Item No. 10.2.1
Regional Centre Community Council
February 24, 2021

SUBJECT: Case 23161: Appeal of Site Plan Approval – 6459 Bayers Rd., Halifax

6459 Bayers Rd.,
Halifax - New 8 Unit
Building

1 Elevation - Front (Small Scale)
1/16" = 1'-0"

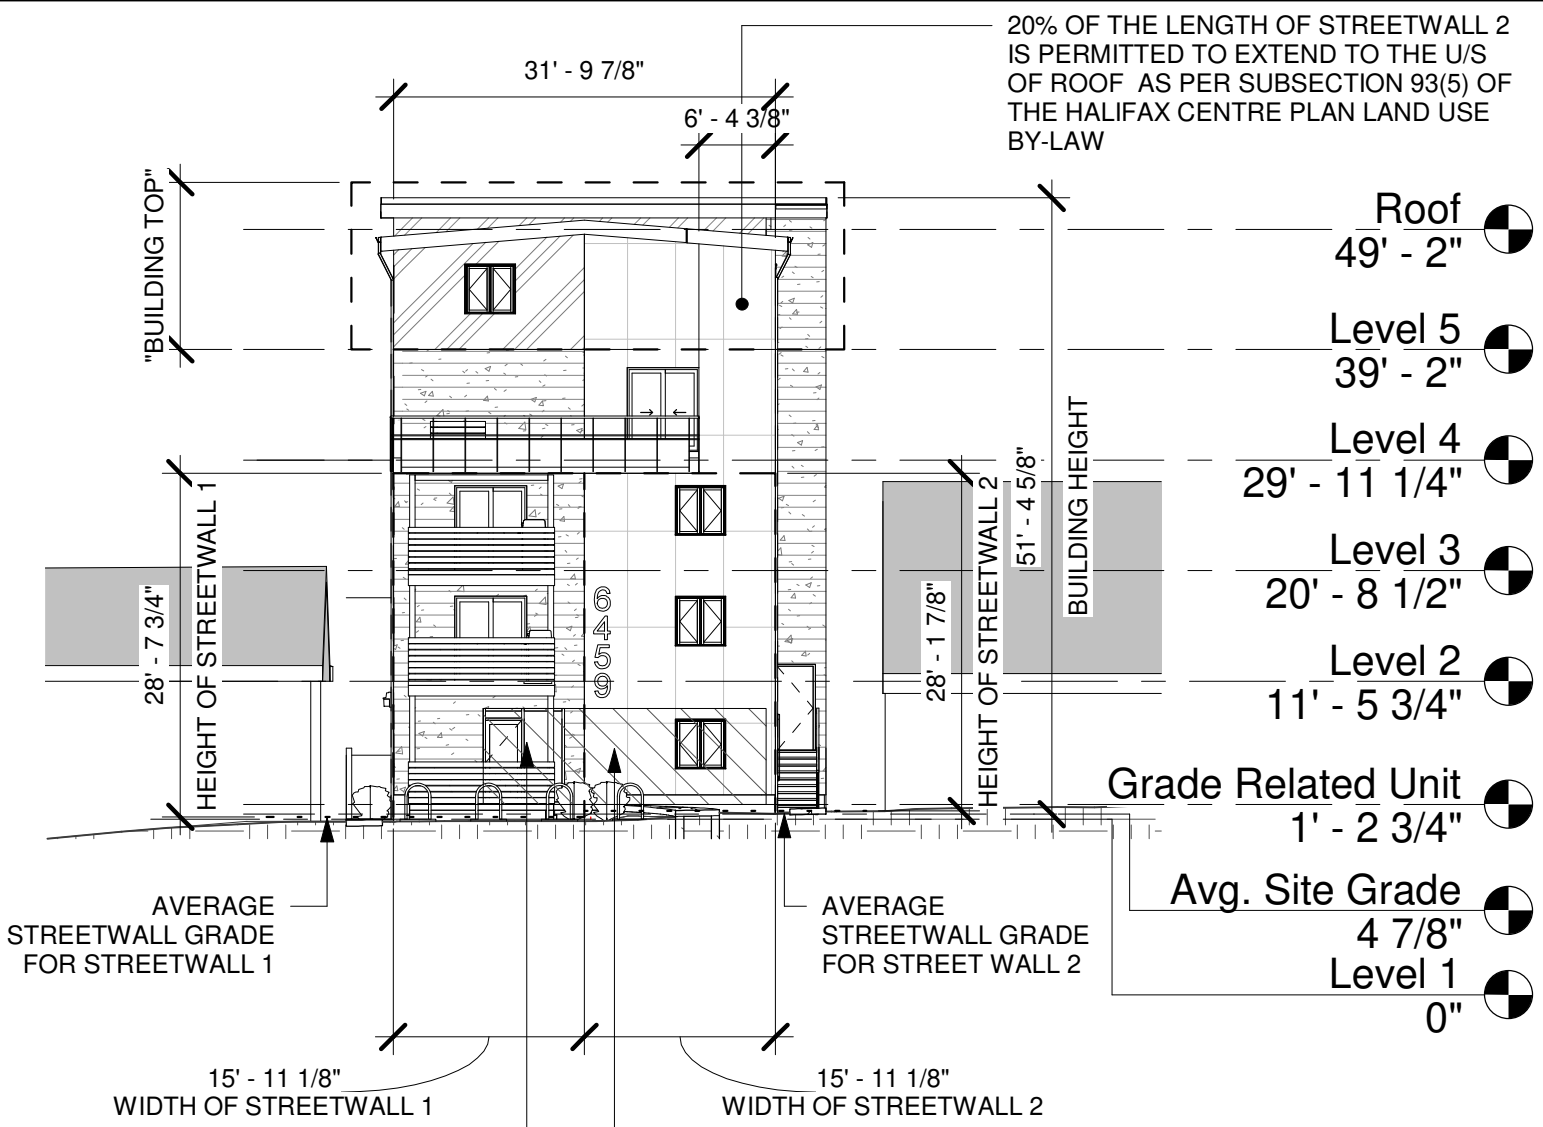
<p><u>Part VI, Chapter 3, Section 128: Ground Floor Transparency – Grade Related Uses</u> We are seeking clarification on the calculation used to determine the amount of glazing required. Without a floor plan, we are unable to determine how much of the streetwall is dedicated to the grade-related unit. Assuming the entire width of the ground floor façade relates to the grade-related unit (9.7 m width by 3.0 m height), the 50 square foot of glazing provided by the one window and door would not meet the minimum requirement of 25%.</p>	<p>A portion of the building along the streetwall is used for common building utility or storage purposes. Based on the area of the remaining portion of the streetwall, 4.4 square metres of glazing is required, and the proposal includes 4.6 square metres of glazing, which meets the requirement.</p>
<p><u>Part VI, Chapter 6, Section 154: General Lighting</u> It is unclear in the plans and drawings provided if the doorway and stairs shown on the front elevation is a common access or not. More broadly, we have concerns about the type of lighting being proposed as this has the potential to directly impact neighbouring properties. For example, the main shared entrance is located on the side of the building and immediately adjacent to the existing residence and lighting for the private open-space in the rear yard could impact all abutting properties.</p>	<p>The building entrances on the front elevation are not common building entrances, and are not required to be illuminated under section 154, although there is nothing prohibiting this from being illuminated. Regardless of the function of the entrance, section 47 of the land use bylaw prohibits light from being directed towards streets or adjacent properties, and requires the use of full cut-off lighting fixtures. Specific details of lighting fixtures have not been provided yet, as this is not a design requirement, but it will be a confirmed as part of the permit review. The lighting requirements are outside the scope of the consideration of the appeal.</p>

Appeal: We are seeking clarification on the calculation used to determine the amount of glazing required. Without a floor plan, we are unable to determine how much of the streetwall is dedicated to the grade-related unit. Assuming the entire width of the ground floor façade relates to the grade-related unit (9.7 m width by 3.0 m height), the 50 square foot of glazing provided by the one window and door would not meet the minimum requirement of 25%.

AREA OF BUILDING FACE DEDICATED TO GRADE RELATED UNIT = 188.8 SQ.FT

REQUIRED CLEAR GLAZING = 25% = 47.2 SQ.FT.

ACTUAL CLEAR GLAZING = 50 SQ.FT

Project Number	20-072
Date	2020.11.20
Scale	As indicated
Sheet	A3

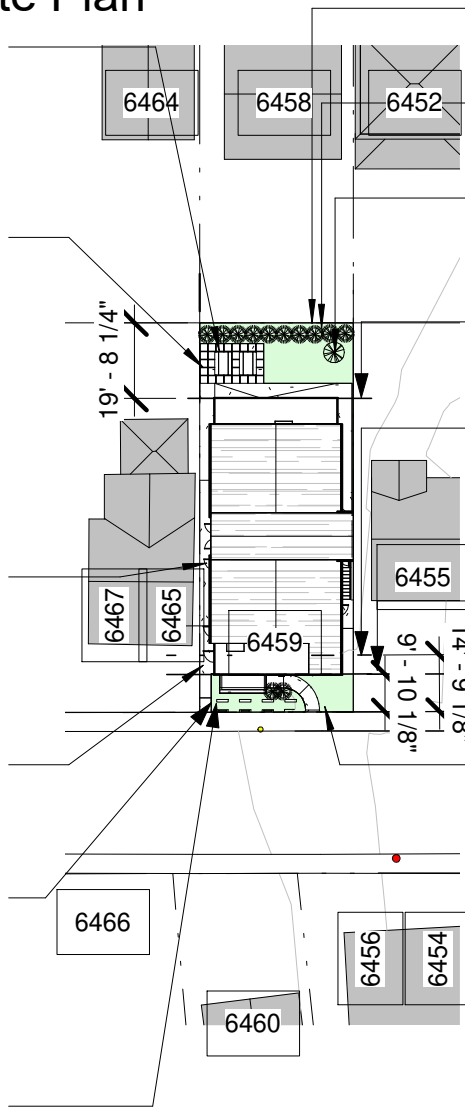
<p><u>Part VI, Chapter 2, Section 114: At-Grade Private Open Spaces Abutting a Public Sidewalk</u></p> <p>No dimensions have been given for the walkway connecting the at-grade private open space for the unit fronting Bayers Road and the Bayers Road sidewalk. On the site plan it appears to be less than 2.0 m in width based on the dimensions provided for the 3.0 m building setback.</p> <p>The public realm and relationship of the building to the street could be improved by having a deeper front patio for the at-grade unit fronting Bayers Rd. This would better relate to the street and improve the usability of this space particularly for persons with mobility challenges who may otherwise benefit from an at-grade dwelling.</p>	<p>The open space in front of the grade-related unit is a patio, which is required under section 90(4)(a) of the land use bylaw and must be a minimum depth of 1.5 metres. The patio is considered a required part of the building, and as such, does not constitute an at-grade private open space, and does not have to meet the 2 metre pedestrian access requirement.</p> <p>Accessibility considerations are contained within the building code, not the land use bylaw. Before a construction permit can be issued, the Building Official will have to be satisfied that the units meet any applicable accessibility requirements.</p>

<p><u>Part VI, Chapter 2, Section 116: Weather Protection for At-Grade Private Open Spaces</u></p> <p>A new deciduous tree with a base caliper of at least 100 mm is shown on the site plan however, it is located at the far side of the rear yard and not adjacent to the seating area offering little weather protection for those using the seating area. The site plan refers to a separate zoning requirement for the tree which relates to requiring landscape buffers along the transition line rather than weather protection.</p>	<p>Weather protection for the at-grade private open space is provided by the referenced deciduous tree, as well as the balconies which cantilever over the rear entrance to the building, which are both listed as options in section 116. While the new deciduous tree is required as part of the landscaping buffer, there is nothing in the bylaw which precludes the use of this tree to satisfy both the requirements for weather protection and landscaped buffering.</p>

Appeal: No dimensions have been given for the walkway connecting the at-grade private open space for the unit fronting Bayers Road and the Bayers Road sidewalk. On the site plan it appears to be less than 2.0 m in width based on the dimensions provided for the 3.0 m building setback.

Appeal: a new deciduous tree with a base caliper of at least 100 mm is shown on the site plan however, it is located at the far side of the rear yard and not adjacent to the seating area offering little weather protection for those using the seating area. The site plan refers to a separate zoning requirement for the tree which relates to requiring landscape buffers along the transition line rather than weather protection.
